Item Name: Upper Cutter Assy

ENGINEERING CHANGE NOTICE NO.

DWG NO. 646.3300

DWG TITLE: UPPER CUTTER ASSY

SHEET 5 IS:

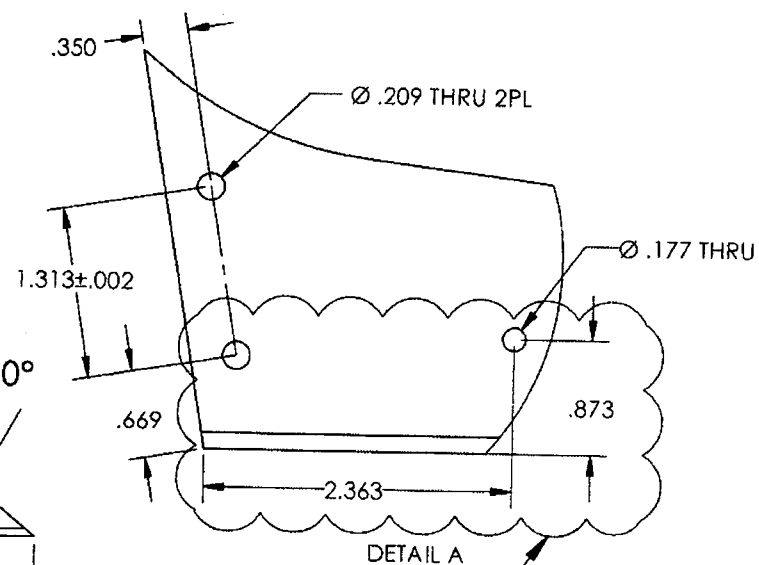
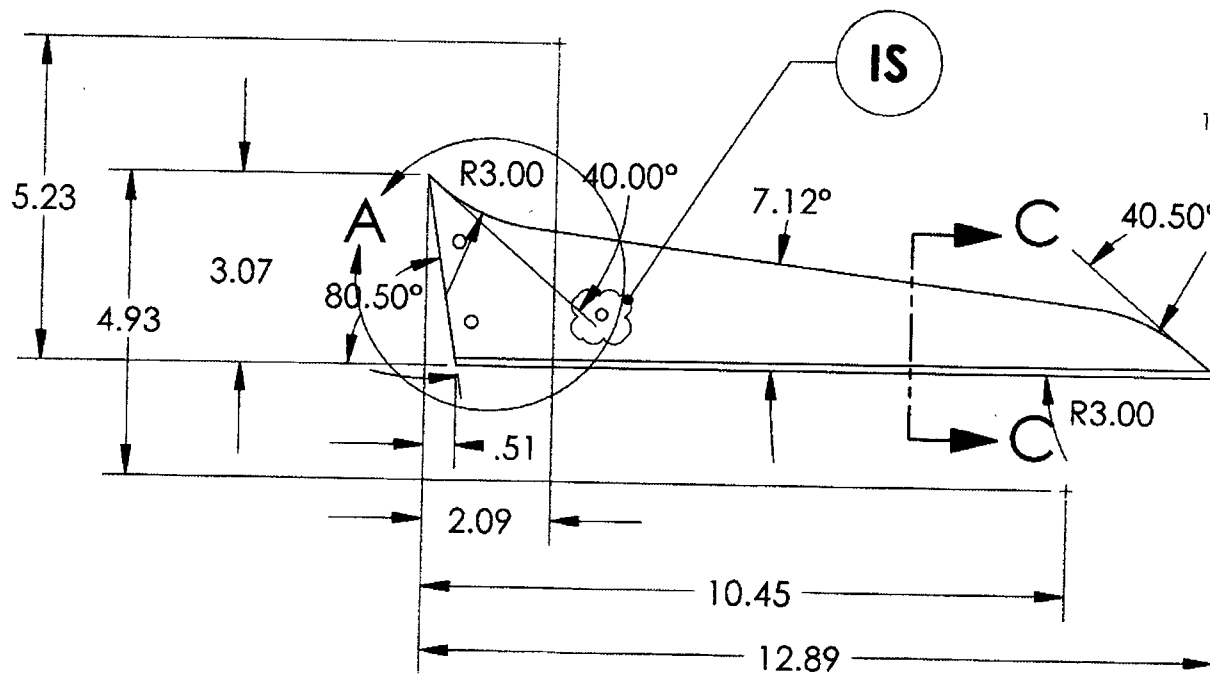
REASON: ADDED HOLE DIMENSION TO 646.3313.

SHEET 4, ZONE B8 IS:

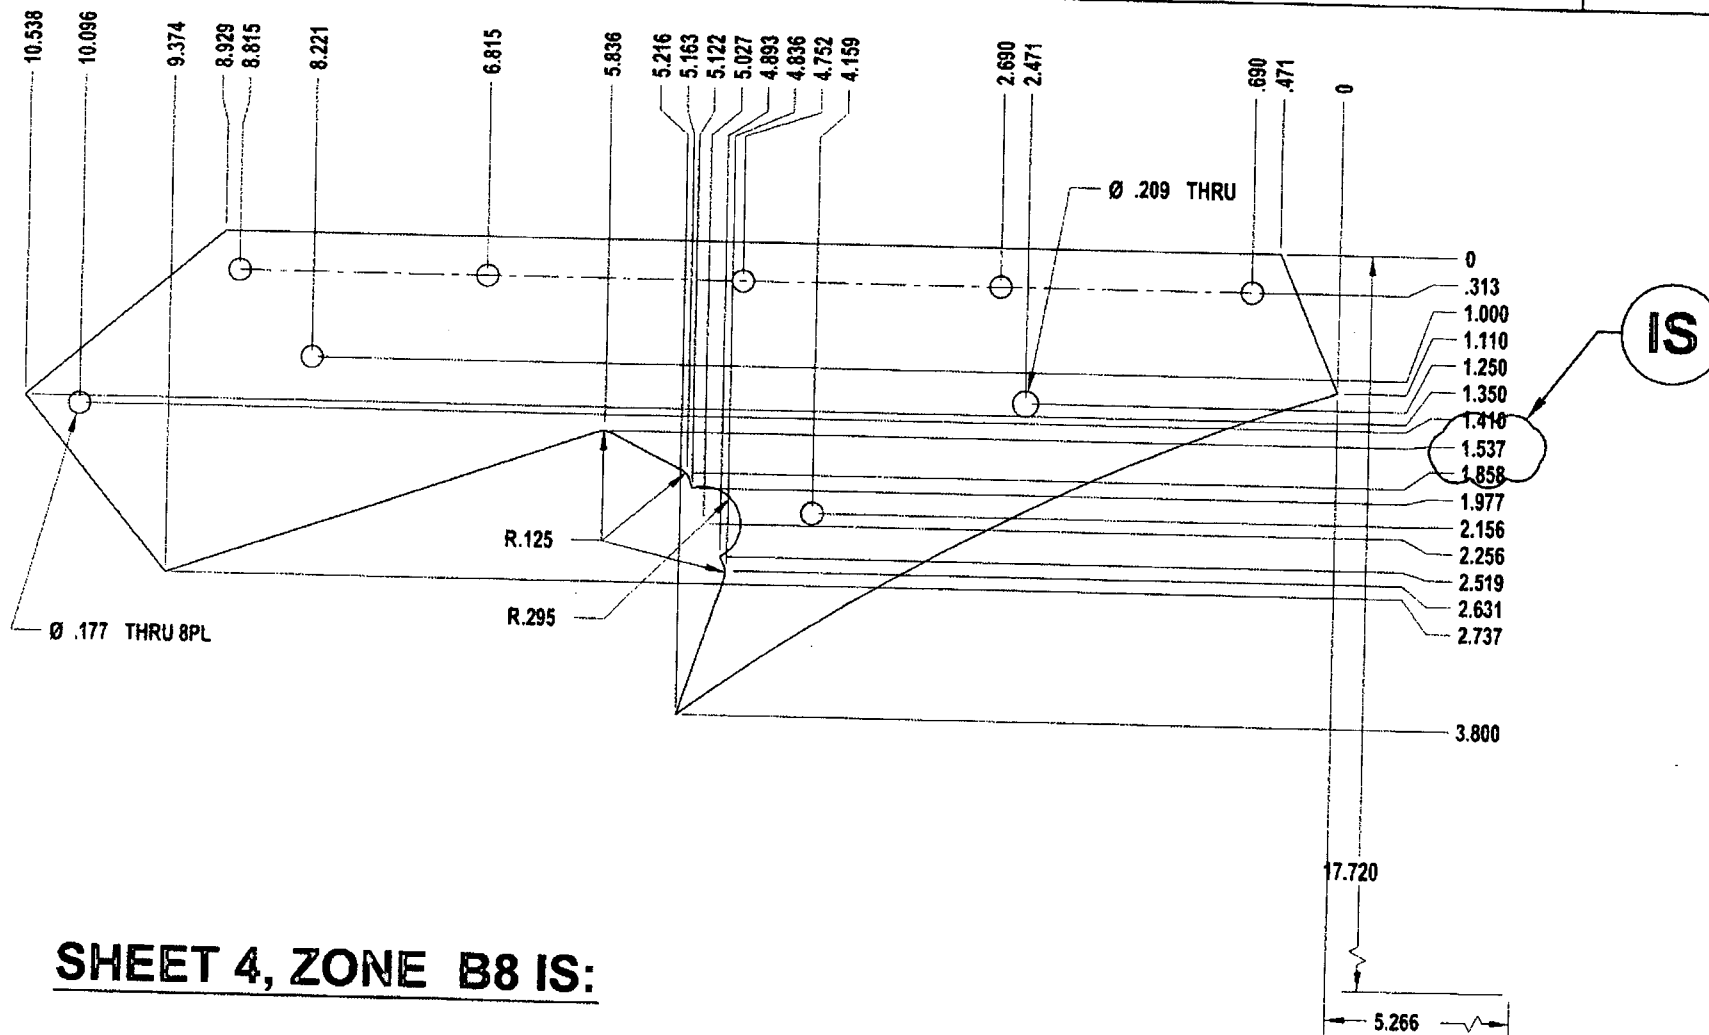
REASON:
REVISED ORDINATE DIMENSION.

SHEET 1, VIEW 646.3301, IS:

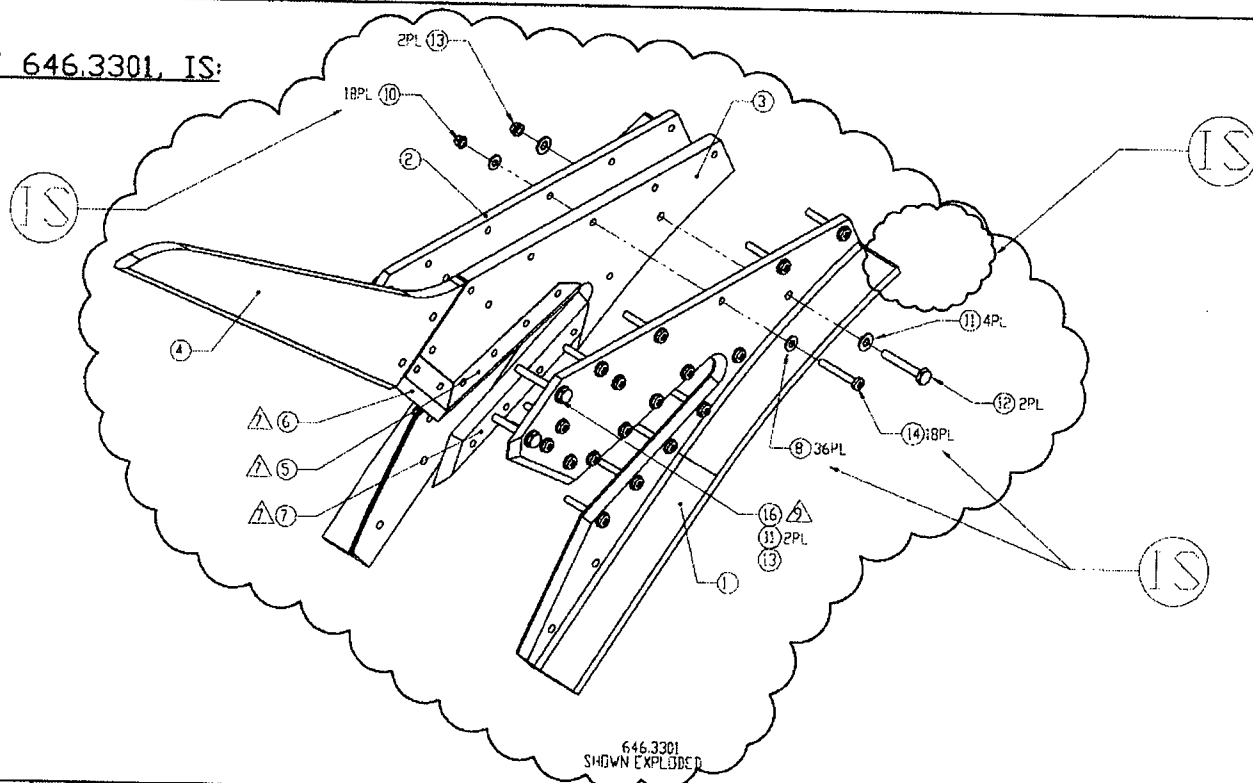
REASON: REMOVED RIVETS IN FAVOR OF ADDITIONAL SCREWS

14	R	601.2765	18	SCREW	MS27039-0819
10	R	601.1541	18	LOCKNUT	MS21042L08
9	D	601.2766	3	RIVET	MS20470AD5-18
8	R	601.2764	36	WASHER	NAS1149FN832P
			3301		
F/N	TC	PART NUMBER	QTY	DESCRIPTION	MATERIAL/SPECIFICATION
DOCUMENTS EFFECTED:				☐ MDL ☒ INSTALL INSTRUC ☒ ICA ☐ FMS ☒ BOM	CHANGE CATEGORY ☐ MAJOR ☒ MINOR
					DER REVIEW REQUIRED ☐ YES ☒ NO
